**SUPPLEMENTAL
ENVIRONMENTAL IMPACT REPORT**

SILVA VALLEY PARKWAY INTERCHANGE PROJECT

June 2011

FIGURE 4

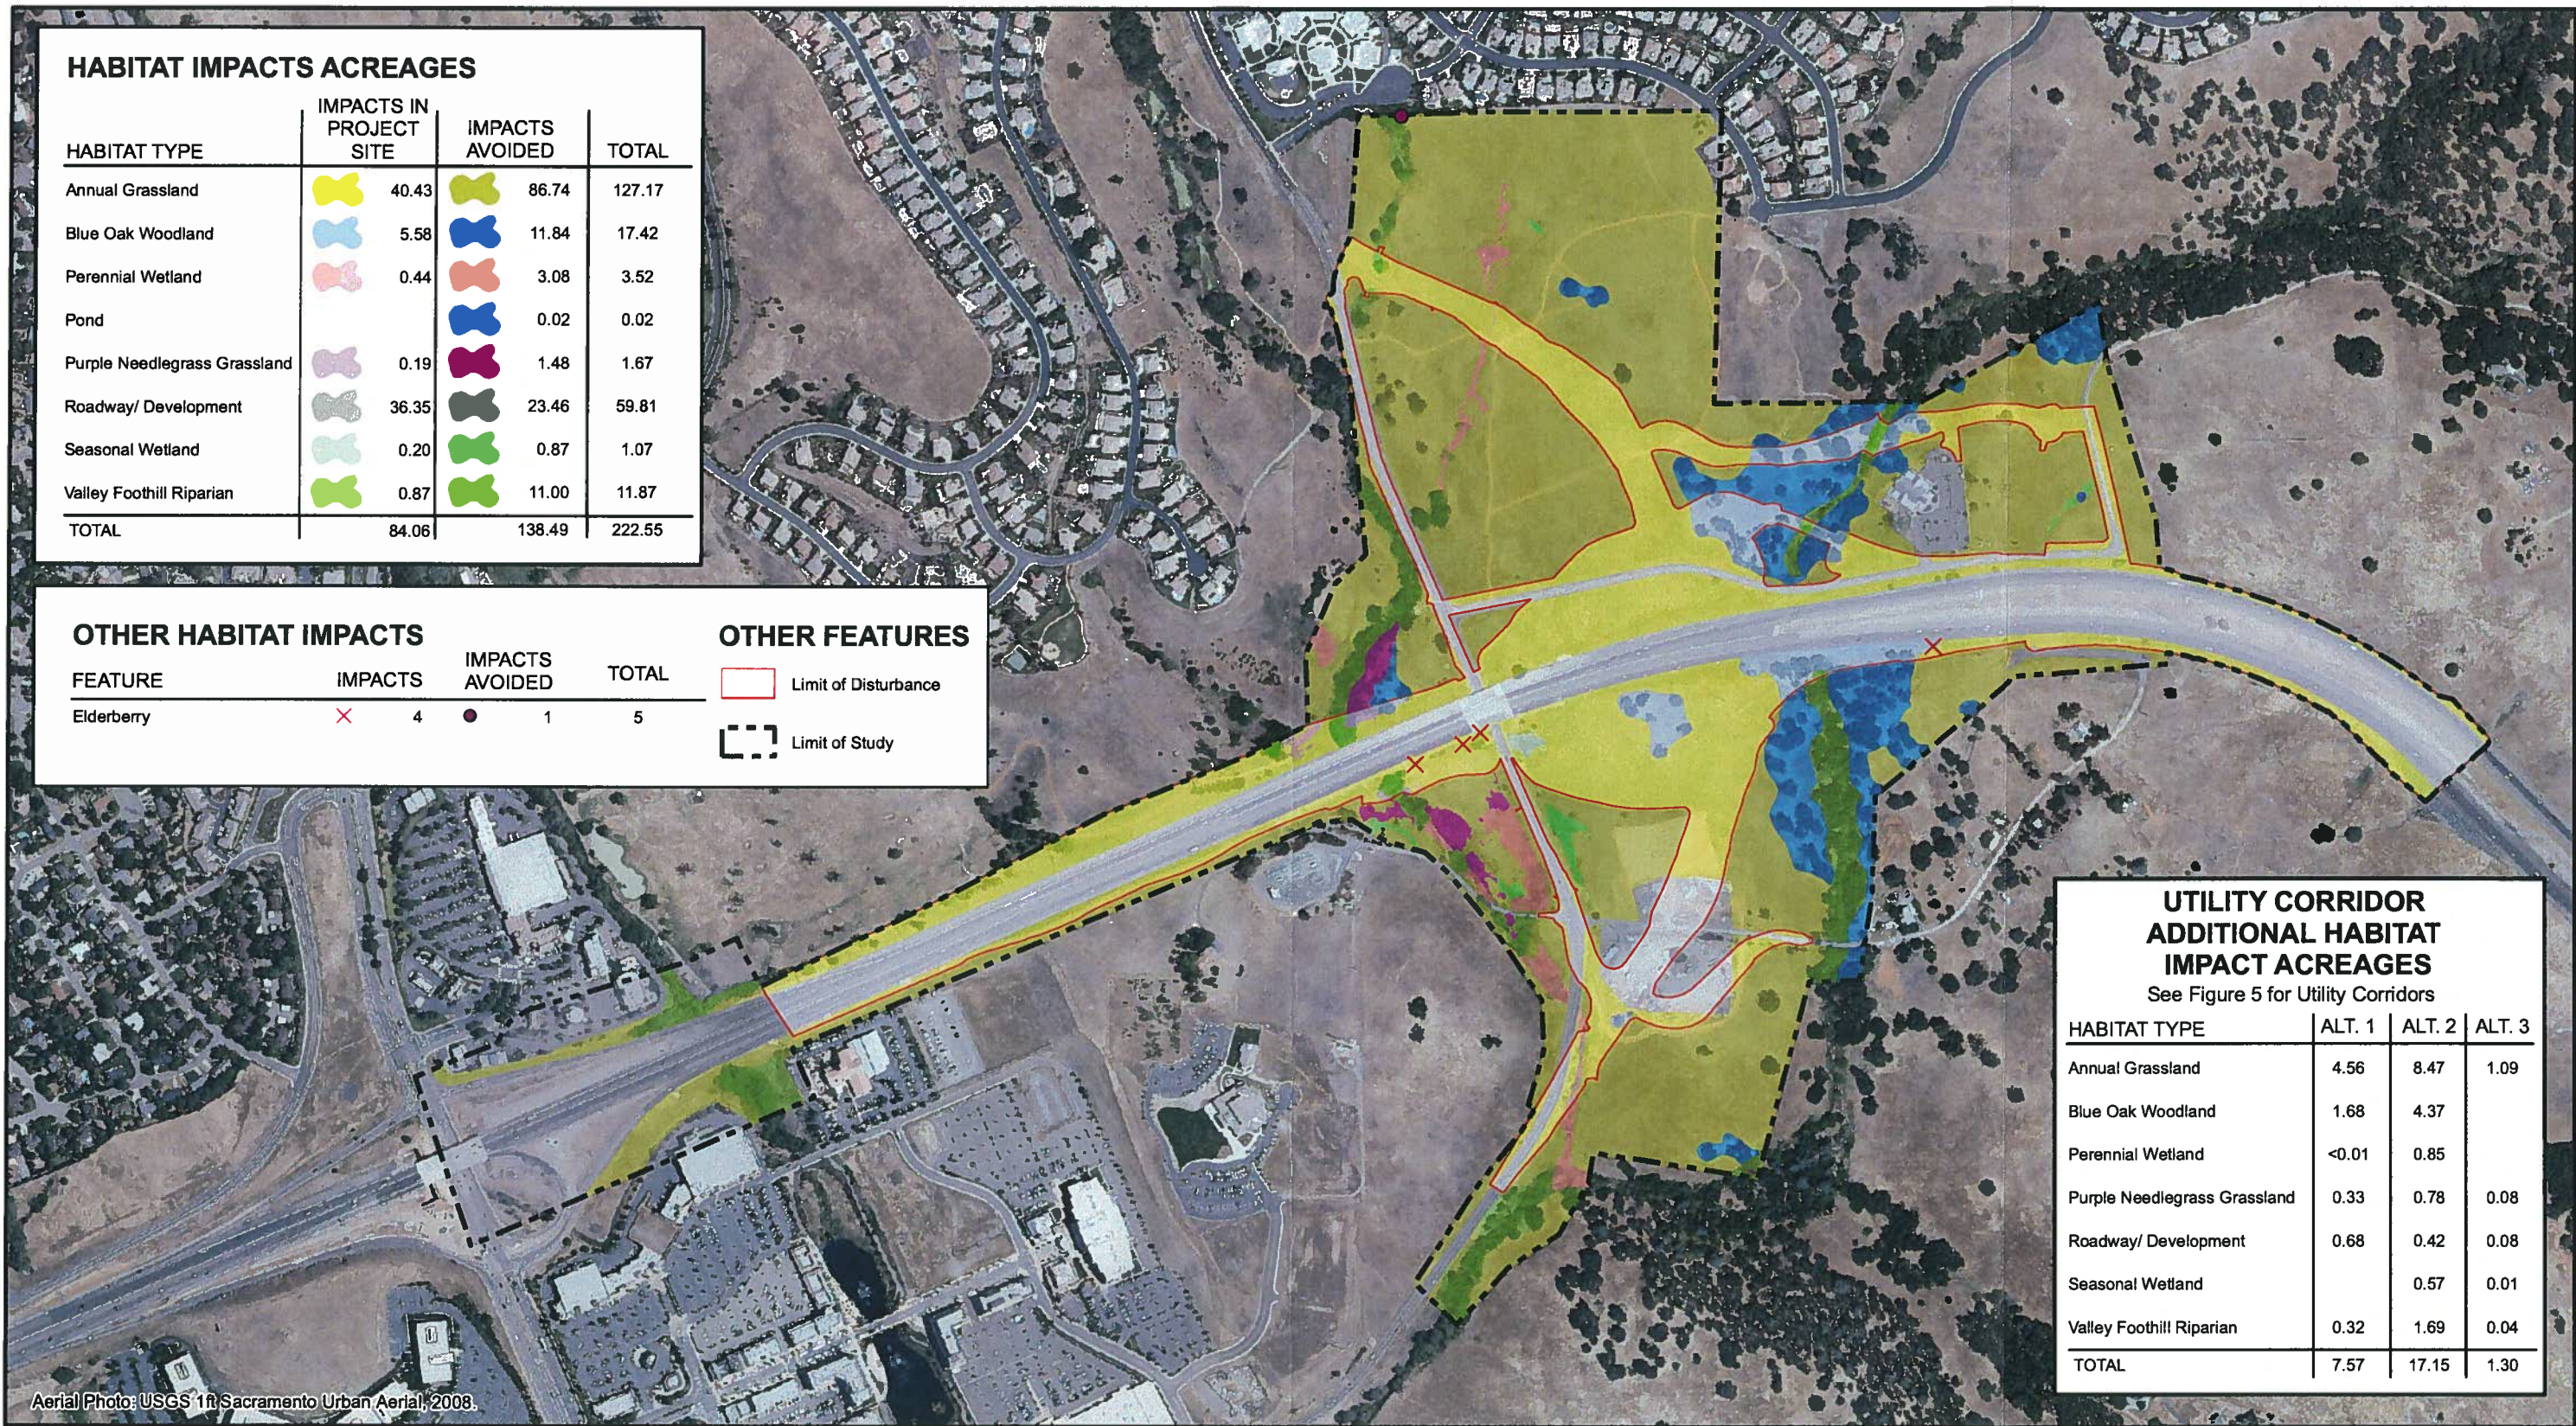
Page 42 – *Figure 4: Utility Corridor Additional Habitat Impact Acreages* identifies the Limit of Disturbance (LOD) for the proposed Project activities. However, the LOD does not include all of the EID utility modifications necessary to meet public service requirements resulting from implementation of the proposed Project. The additional areas that should be included in the LOD are as follows:

Due to the additional areas being impacted by El Dorado Irrigation District utilities, minor changes to biological impacts have occurred (see revised Figure 4). Specifically, these changes include:

EID-3: Figure 4 has been amended to include EID facilities. See Errata section.
